320 Pond Street Design Review Committee Report #1

Prepared by the Ashland Design Review Committee

Submitted to the Planning Board on 1.17.2024

Adaptive Reuse of Mazi restaurant

F. Existing Conditions / Abutters

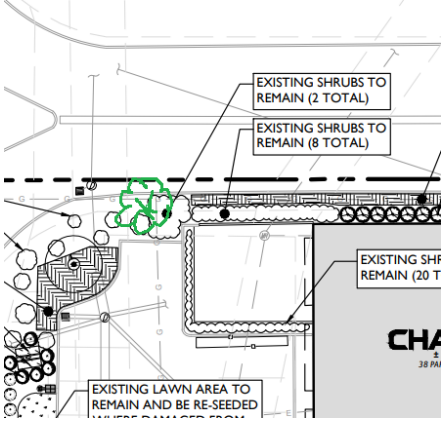
1-F.1	1.4.2024	Relationship with abutters is not affected. No comment.
-------	----------	---
